Subject: 2100 Plus Muncie CS10 & CS11 PTOs

Number: SB 265B DATE: 12/04/2013

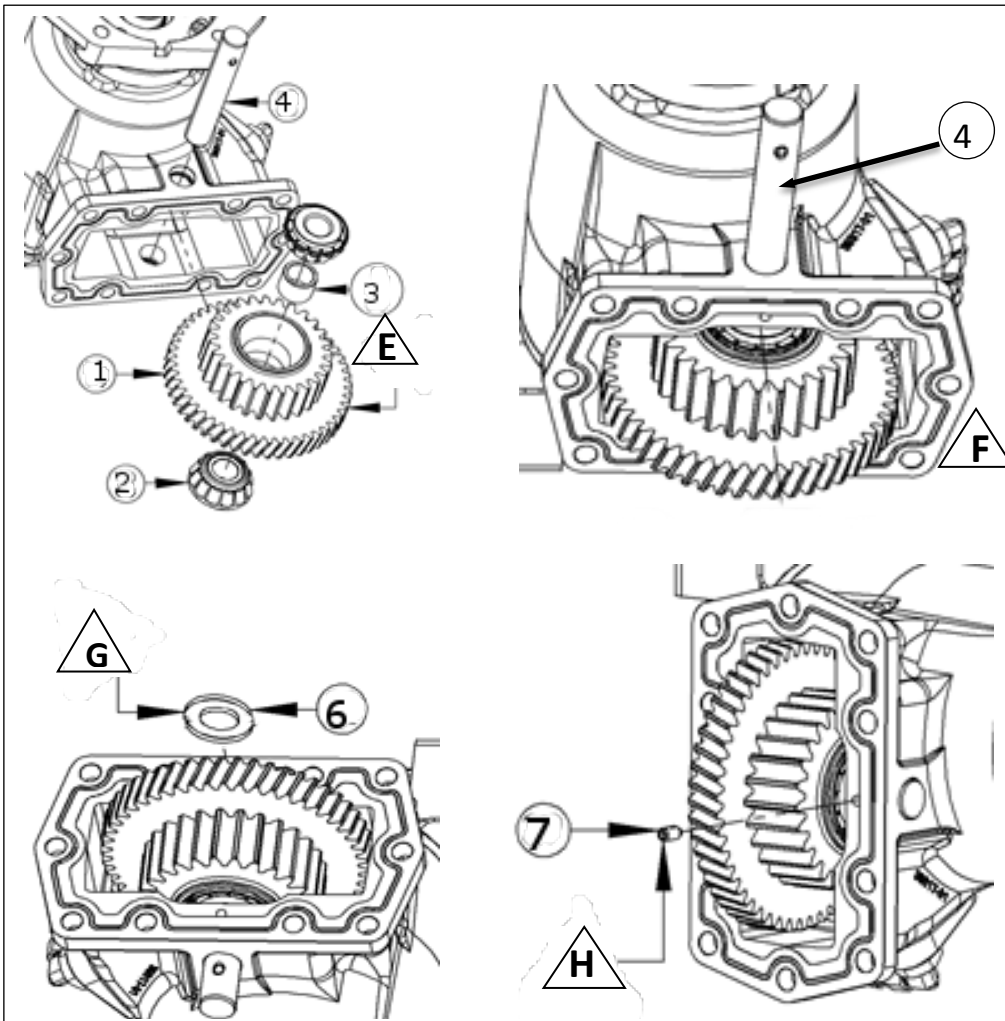
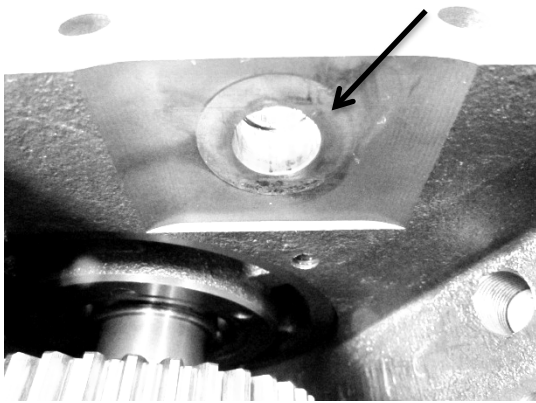
- A. Make a note of the position of the input gear within the housing and the bearing shim next to the gear. Remove the CS10/11 input gear (1) by removing the set screw (7) in the mounting pad and driving the idler shaft (4) from the housing.

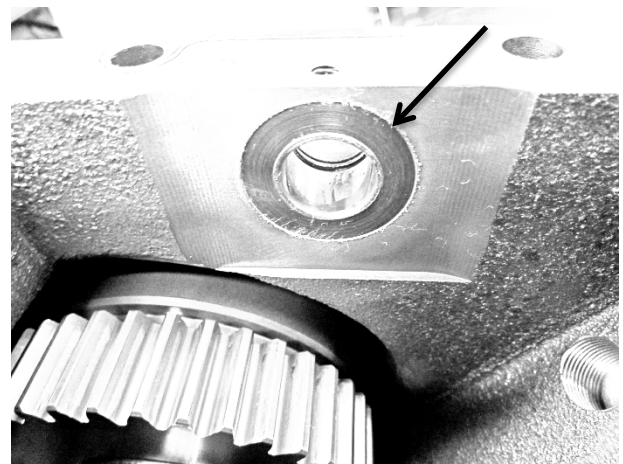
- B. Pry the input gear gently from housing using two pry bars.

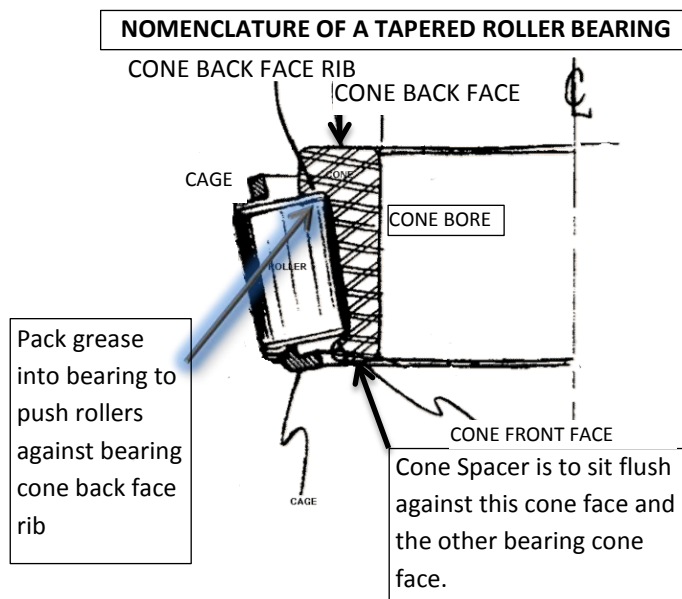
Inspection of the Housing. The area around the idler shaft shows little to no wear. This is an example of no wear.

If the Area around idler shafts shows wear, then the unit needs replacing.
